# WATER QUALITY MEMORANDUM

Utah Coal Regulatory Program

RE: 2010 1st Quarter Water Monitoring, Sunnyside Cogeneration Association, Sunnyside Refuse/Slurry, C0070035, WQ010-1, Task 3487

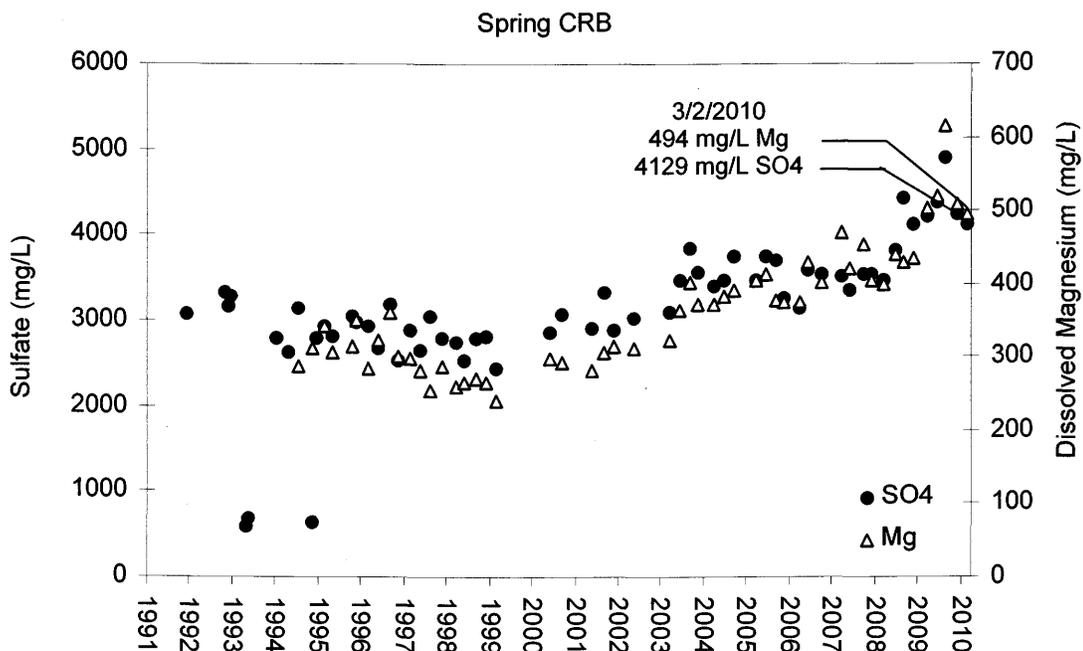
Dissolved magnesium and sulfate concentrations appear to be increasing at spring monitoring location CRB (see plot on following page). The concentrations reported for first quarter 2010 are consistent with recent data, as shown in the plot.
